# DOWNTOWN DESIGN REVIEW BOARD

RECOMMENDATION BOOKLET

# 600 WALL STREET

SEATTLE, WASHINGTON | DPD# 3015251 | JANUARY 06, 2015

**LEVEL 2**  
 ADMINISTRATION, LEASING, BICYCLE STORAGE, MEP

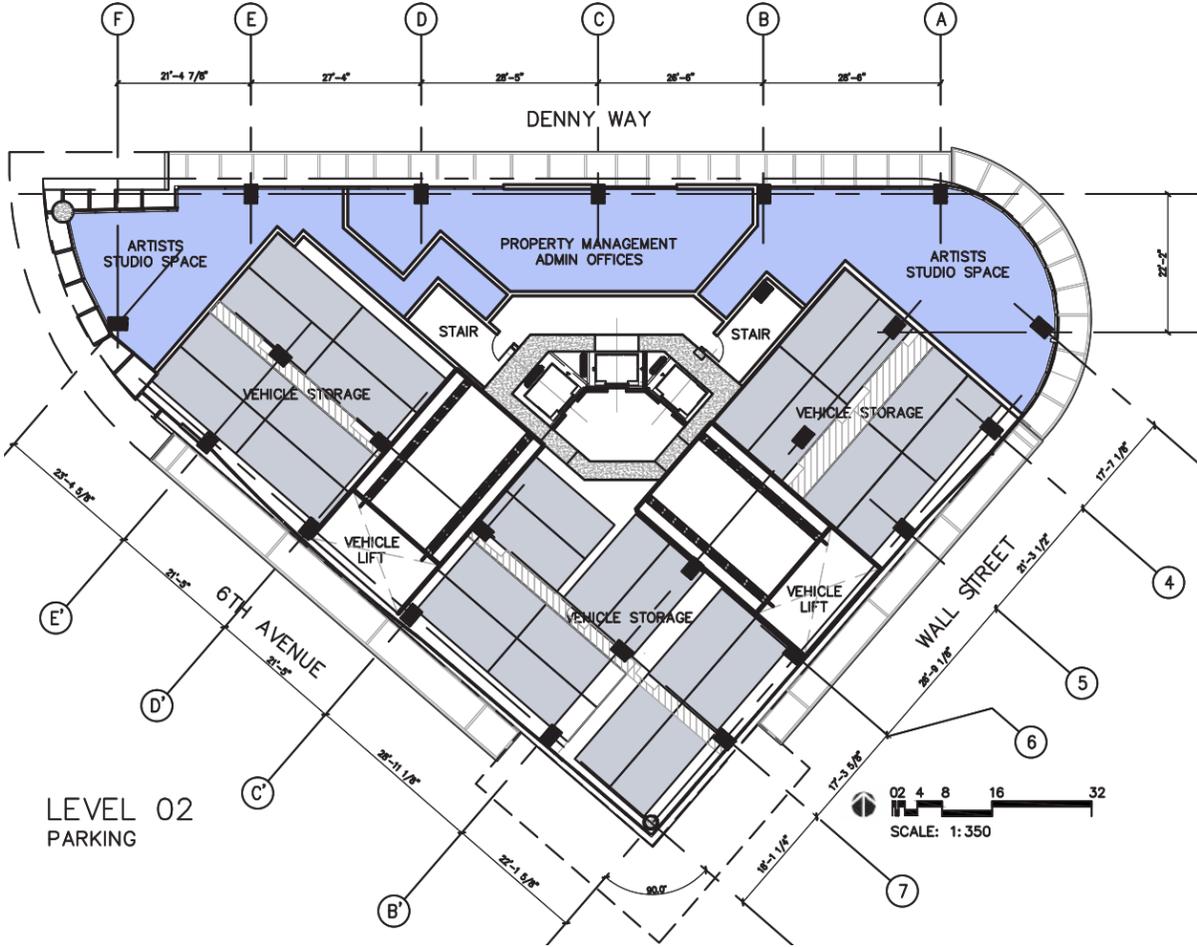
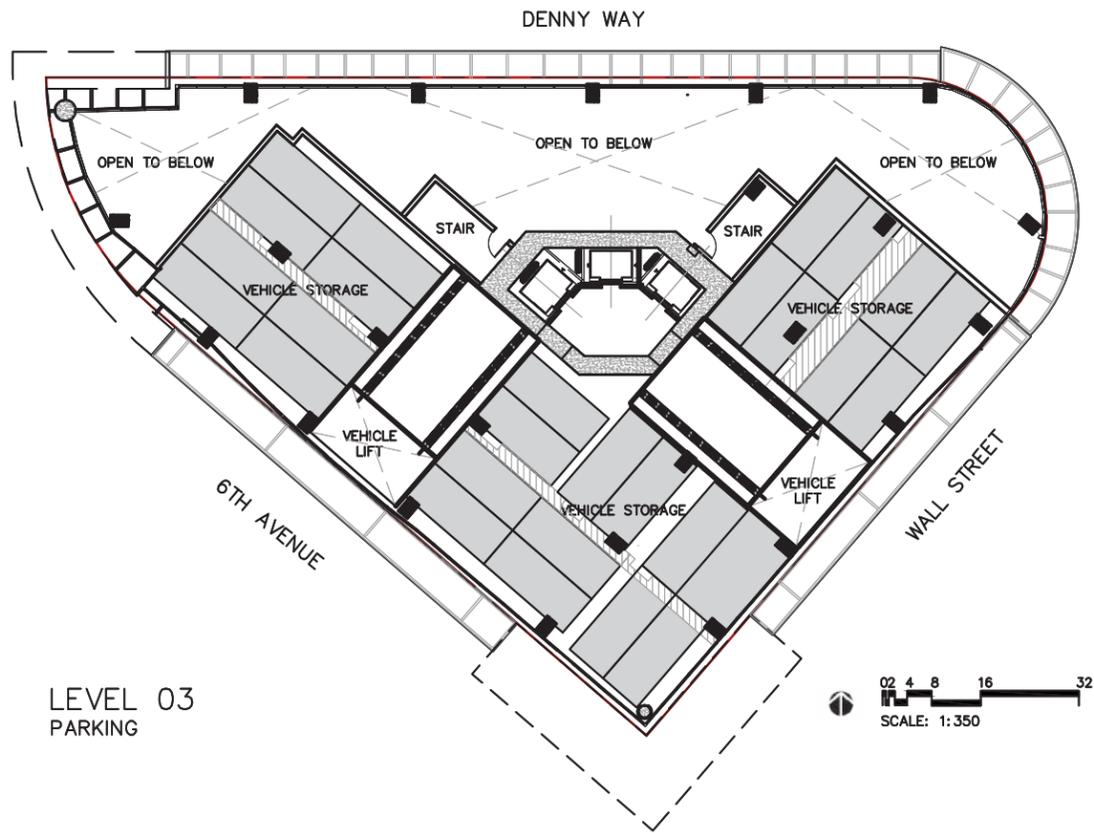
At the Early Design Guidance Meeting #2, the Board supported the proposed transparent and continuous canopies as shown on page 51, but was confused and not supportive of solid canopies suggested on page 45, or the higher one at the 6th and Wall corner. Provide a clear canopy plan, a rationale for the higher canopy, and integrate it into the podium redesign per B-2 guidance.

- The canopies have been redesigned to be transparent and set at heights between 10'-15' continuously around the building.

LEVEL 42  
AMENITY

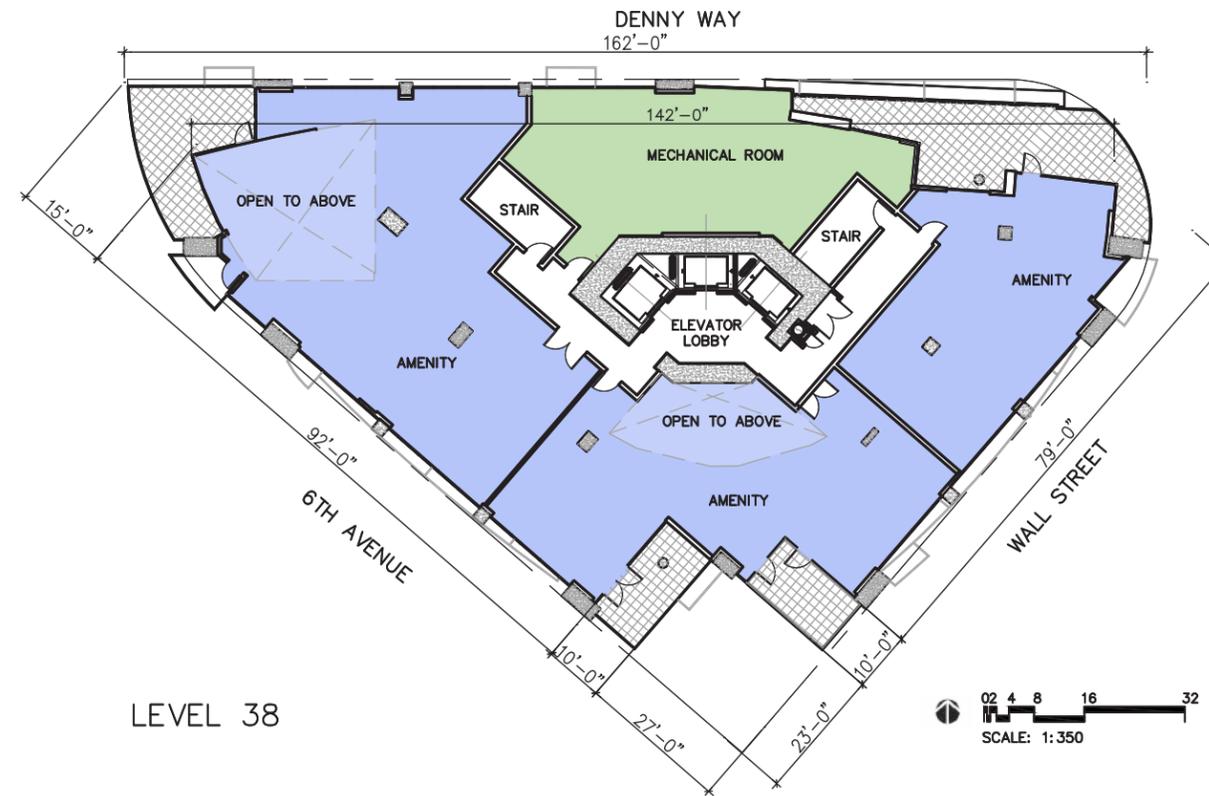
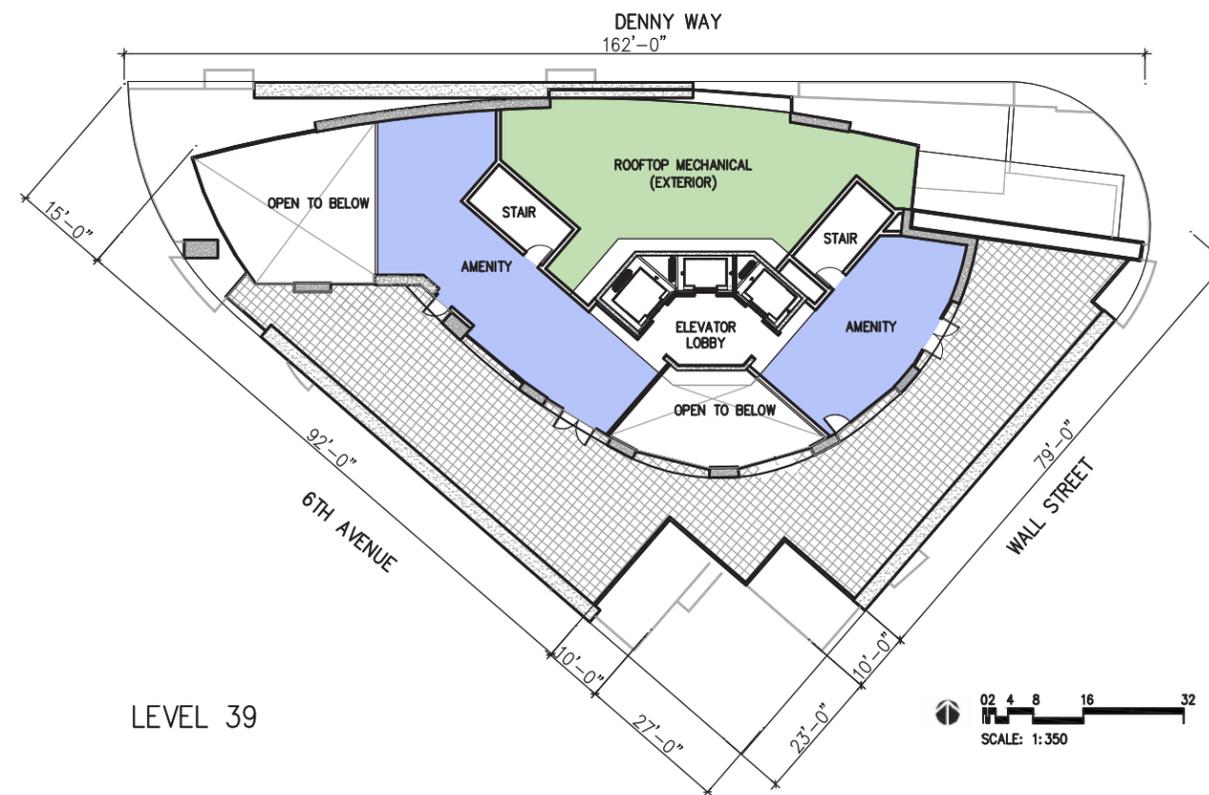
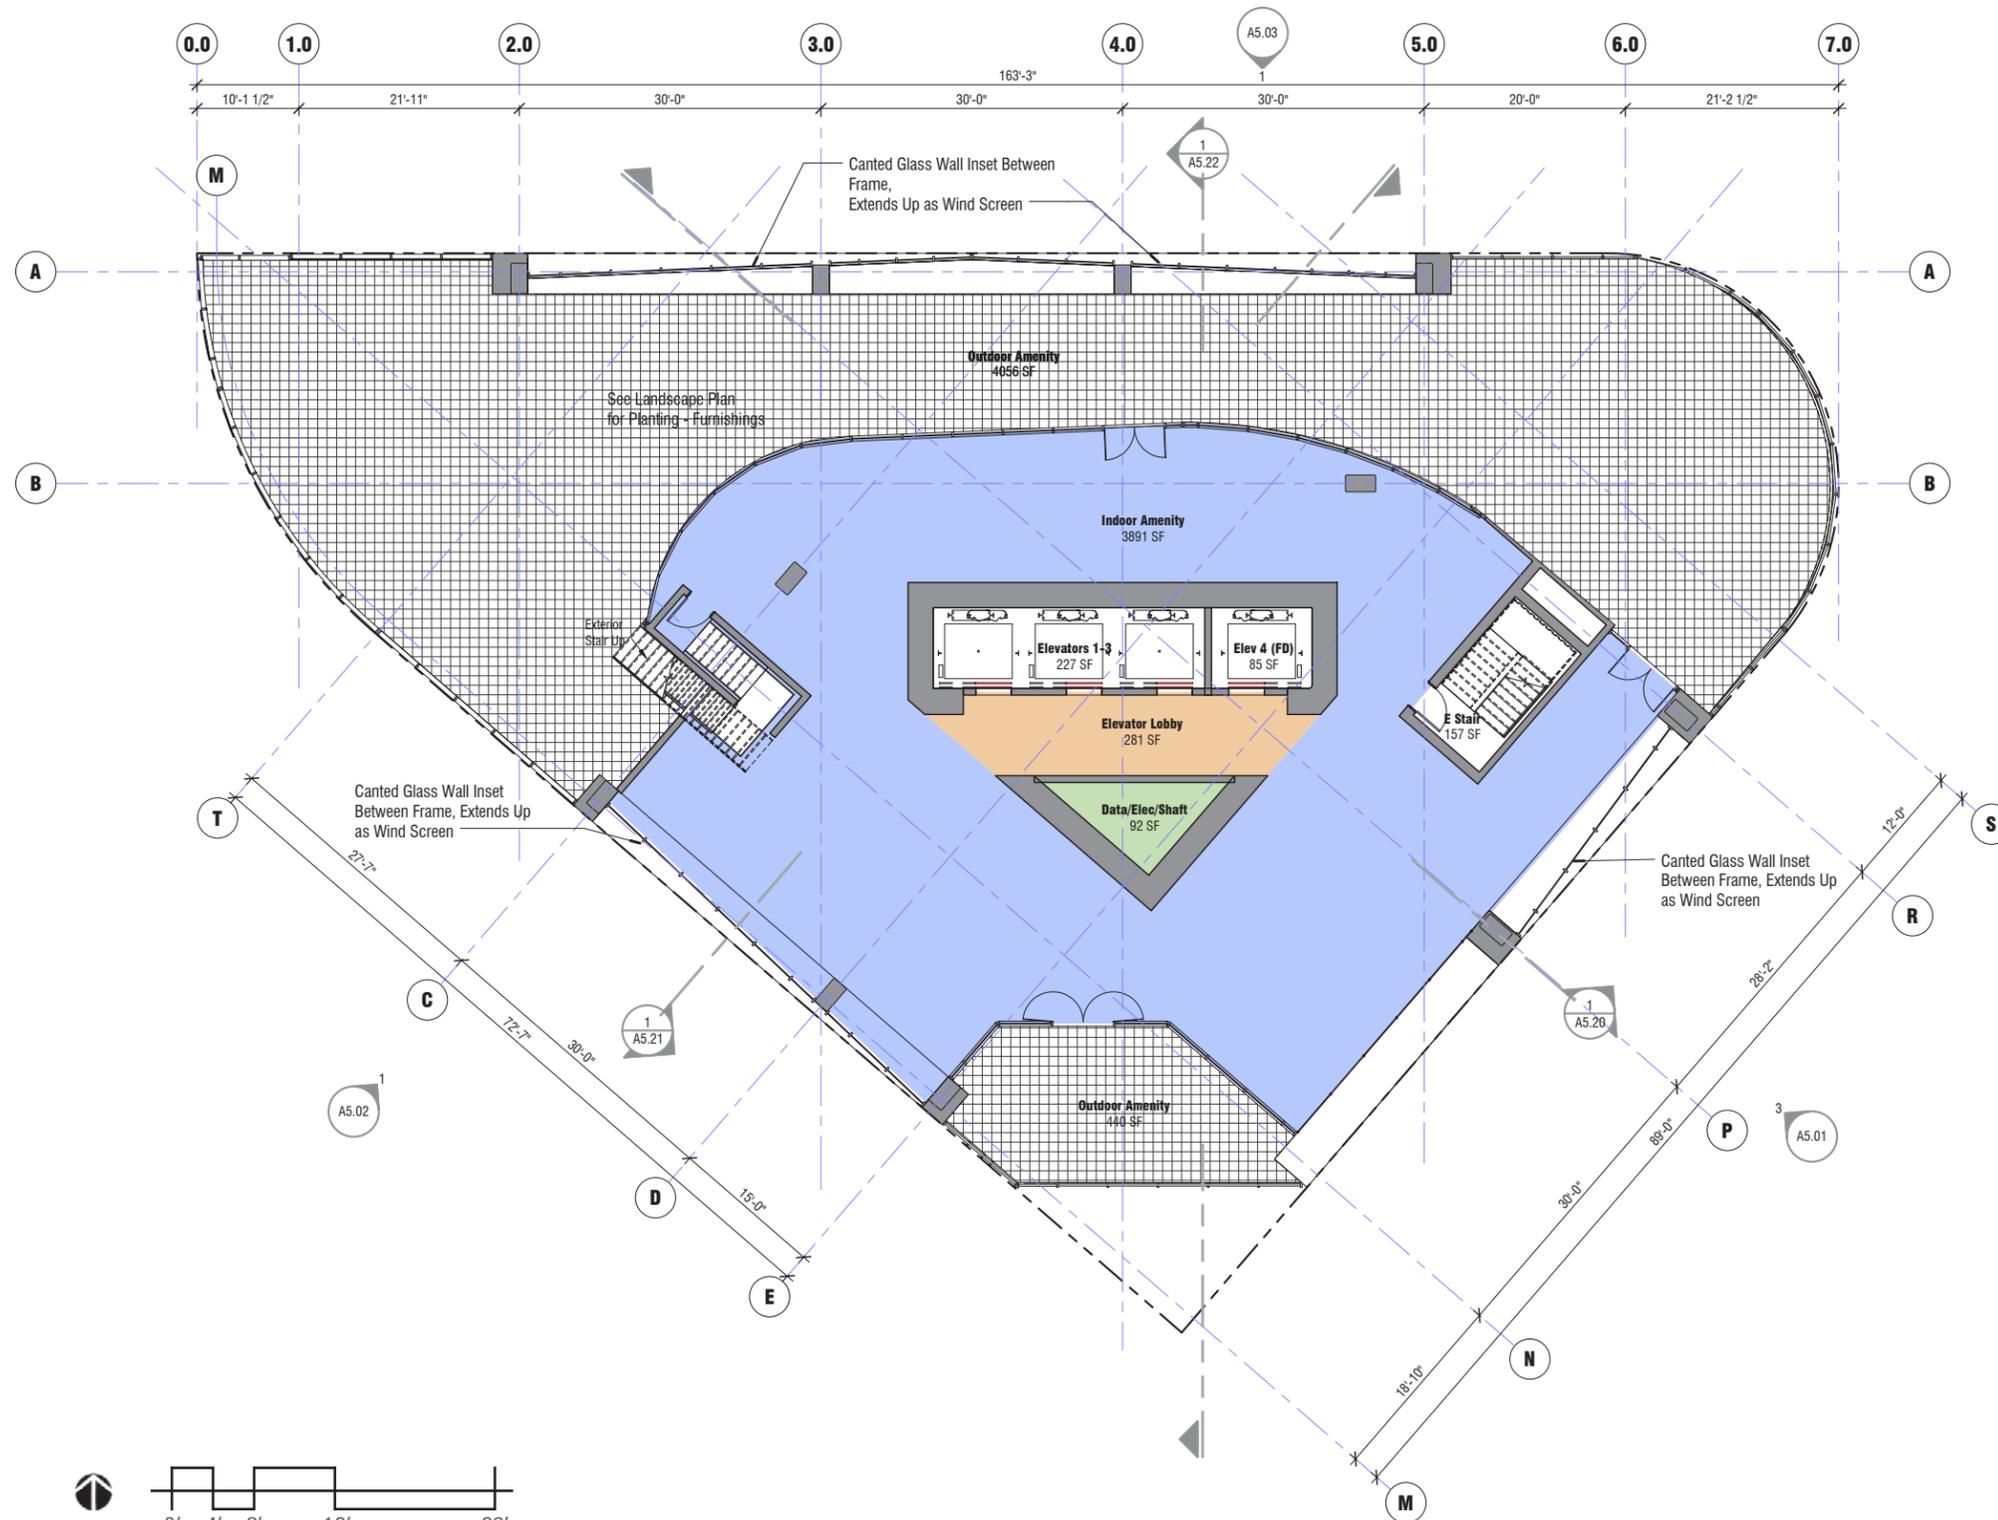
At the Early Design Guidance Meeting #2, the Board appreciated the multiple perspectives provided, and used them to inform the comments under B-2 and B-4. The Board found the tower top composition shown on page 52 promising, especially the spatial interest in the amenity rooms and the generous amount of exterior deck available to the public. However the Board noted the tower top is possibly too busy in material and formal moves, and needs clarification. The Board requested a floor 40 plan (even if mechanical), plus explanatory diagrams, proposed materials and a design rationale for the following elements:

- the three blue fins, which stop at different levels and appear to track through to the sidewalk;
- the semi-circular metal panel wall at floor 39;
- the metal panel curved wall facing Denny, and why it is canted and so similar to the one referenced above?

Based on the page 40-43 perspectives, the tower top provides visual interest, but the Board requests more information to evaluate proportions, materials and composition.

- The tower top has been redesigned to eliminate the confusing architectural elements and continue the use of the design elements at street level. The frames vary in height at each elevation and provide protected outdoor amenity areas.
- The indoor areas offer views in all directions. The 2nd level is spacious and suitable for a fitness center or other residential amenity.
- Materials will be similar to the metal & terra cotta frame and louvers at the podium

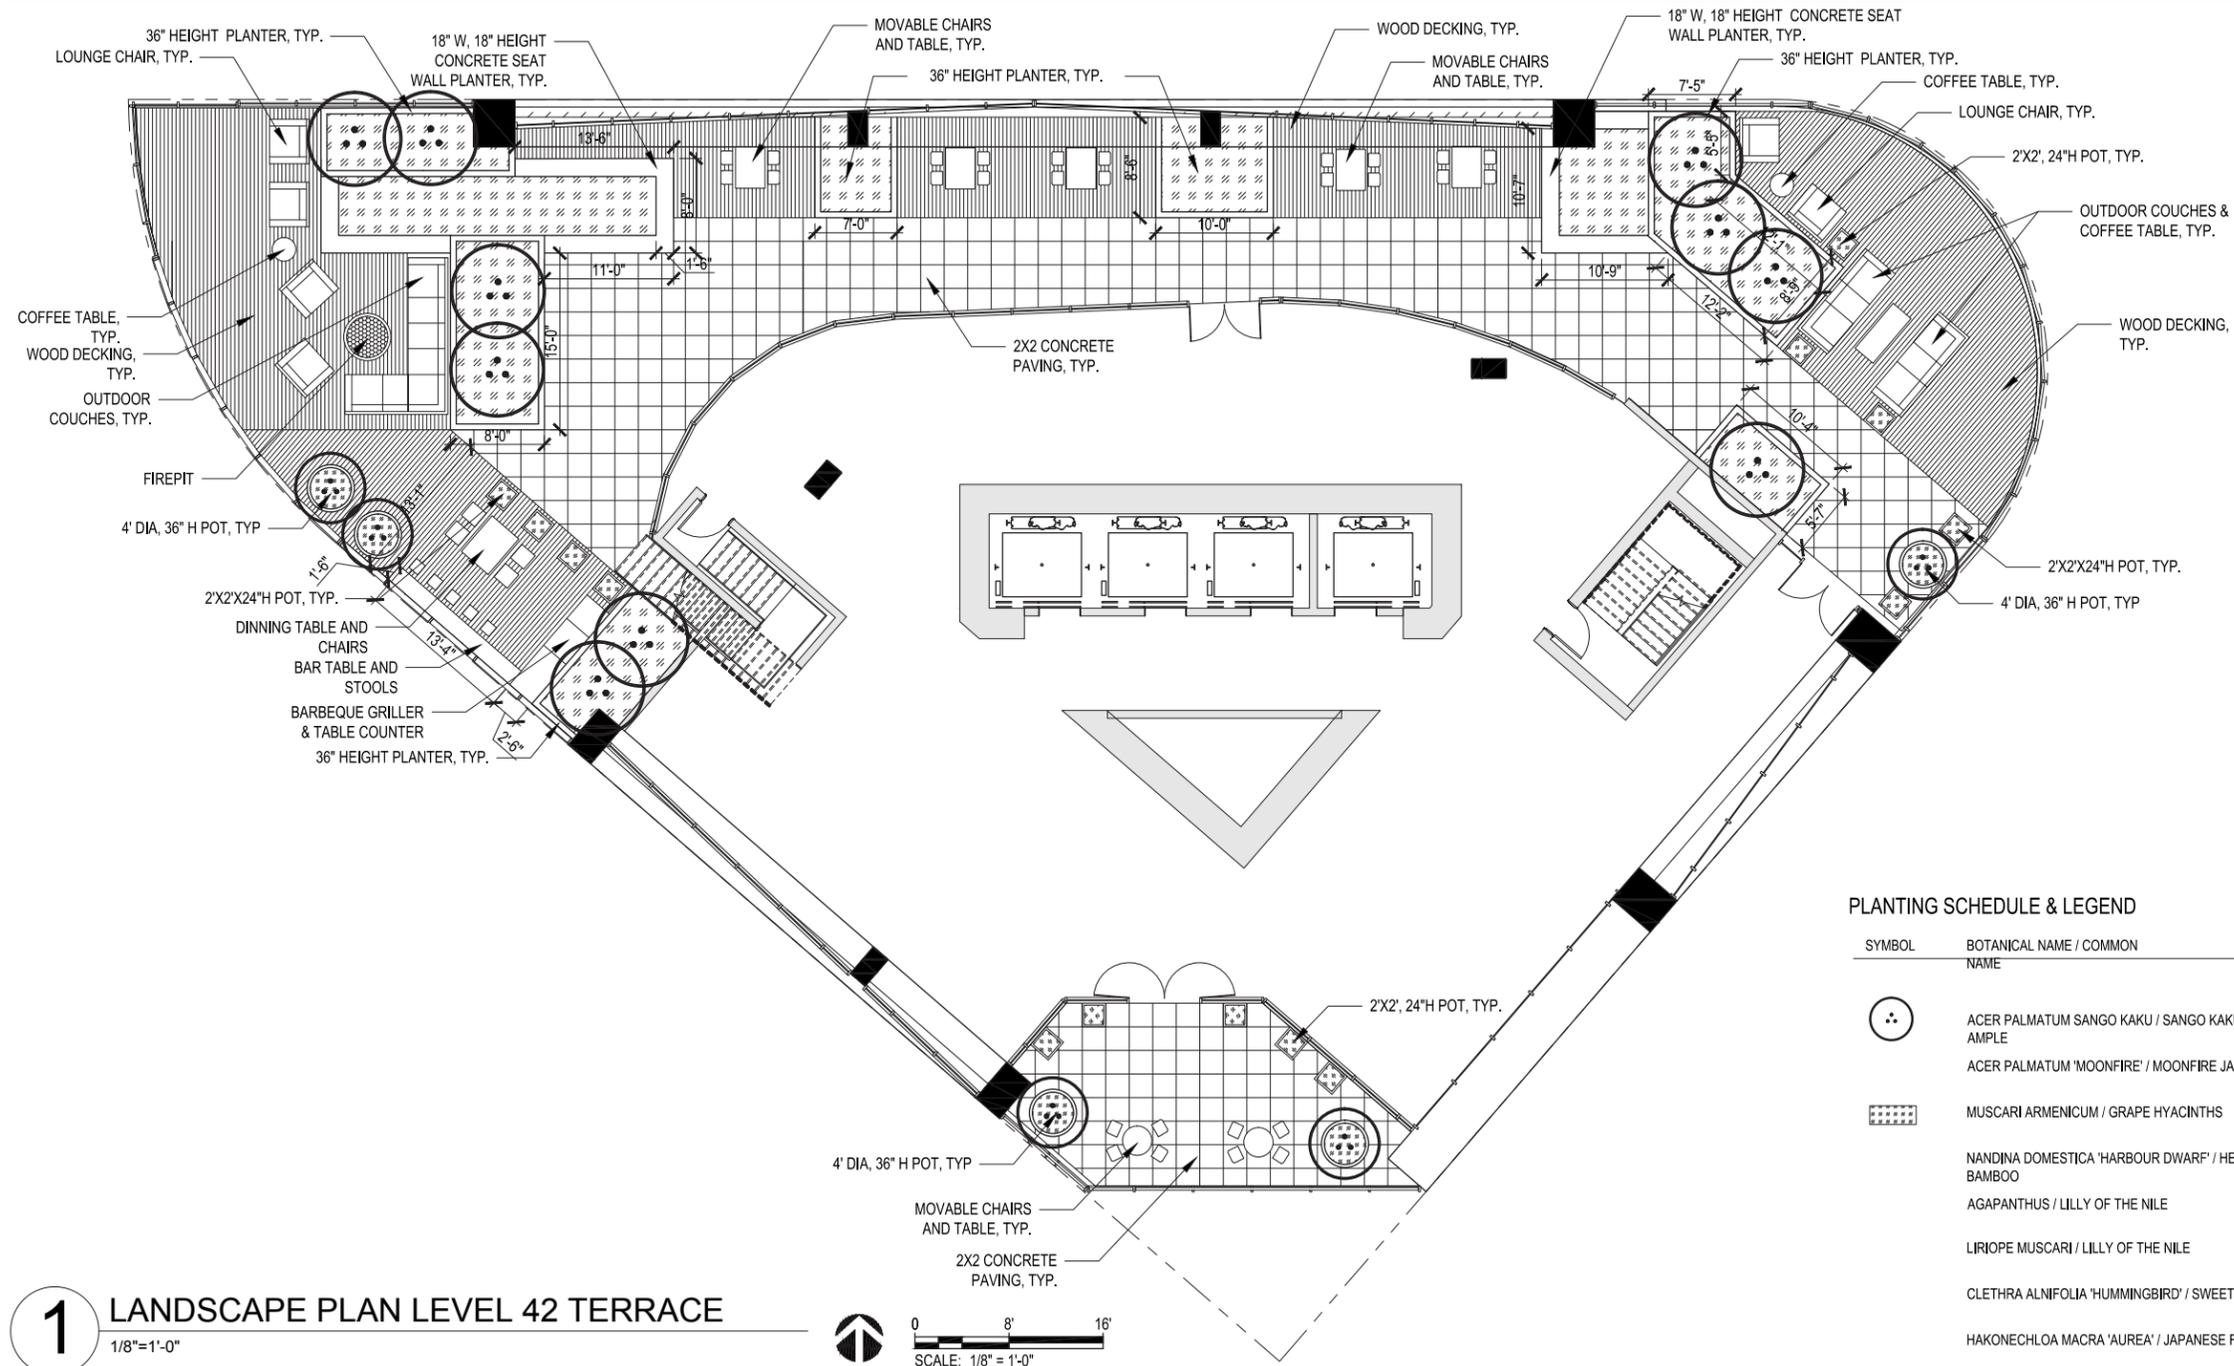
At the Early Design Guidance Meeting #2, the Board supported the bulb-outs and widened sidewalk along Wall Street, and requested the site plan (page 24) show all the adjacent sidewalks and the proposed crosswalks to all corners of the project. The curb ramps shown on page 24 and 50/51 do not align with the crosswalks. The Board requested the next version of drawings clearly describe all paving materials and plant species, and describe seating blocks, cafe seating and other special features. The planter strips should be eased at the intersections to acknowledge pedestrian desire lines, and the landscape palette should accommodate the urban level of activity.

- The Landscape design has been refined as shown in Section 10.0.
